APPLICATION NO.	FILING DATE	FIRST NAMED INVENTOR	ATTORNEY DOCKET NO.	CONFIRMATION NO.
10/573,851	10/06/2006	Osamu Takahashi	OHK-0014	5118
23353 7590 04/17/2009 RADER FISHMAN & GRAUER PLLC LION BUILDING 1233 20TH STREET N.W., SUITE 501 WASHINGTON, DC 20036				
EXAMINER				
MULLINS, BURTON S				
ART UNIT		PAPER NUMBER		
2834				
MAIL DATE		DELIVERY MODE		
04/17/2009		PAPER

# Office Action Summary

10/573,851

**FIG. 6**

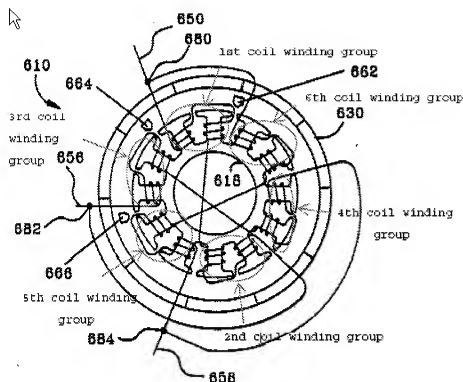
6. Claims 8 and 10-16 are rejected under 35 U.S.C. 103(a) as being unpatentable over Kordik (US 5,164,622) and Burgbacher. Kordik teaches an electromagnetic motor 610 adopting a delta connection structure (abstract; Fig.6), the motor comprising: a coil wire wound at least twice over through a sequence (i.e., coil wound over two sets of poles per phase for each of three phases A/B/C), wherein said sequence is said single coil wire extended: 1) from a first feeding terminal 680 to a first coil winding unit (marked 1 in Fig.6 below), said first coil winding unit to a second coil winding unit (marked 2, Fig.6 below), and said second coil winding unit (2) to a second feeding terminal 682; 2) from said second feeding terminal 682 to a third coil winding unit (marked 3, Fig.6 below), said third coil winding unit (3) to a fourth coil winding unit (marked 4, Fig.6 below), and said fourth coil winding unit (4) to a third feeding terminal 684; and 3) from said third feeding terminal 684 to a fifth coil winding unit (marked 5, Fig.6 below), said fifth coil winding unit to a sixth coil winding unit (marked 6, Fig.6 below), and said sixth coil winding unit (6) to said first feeding terminal 680.

Kordik differs in that there is no teaching of "a single coil wire through said sequence being without any cut".

Regarding claim 10, in Kordik the first through sixth coil winding units (1)-(6) each has a magnetic pole face at a front end (i.e., stator pole faces, Fig.6).

Regarding claim 12, the first and second coil winding units (1) and (2) radially extend from said stator core, said first and second coil winding units being disposed on a diagonal (Fig.6).

Regarding claim 13, in Kordik, the third and fourth coil winding units (3) and (4) radially extend from said stator core, said third and fourth coil winding units being disposed on another diagonal (Fig.6).

Regarding claim 14, in Kordik, the fifth and sixth coil winding units (5) and (6) radially extend from said stator core, said fifth and sixth coil winding units being disposed on a different diagonal (Fig.6).
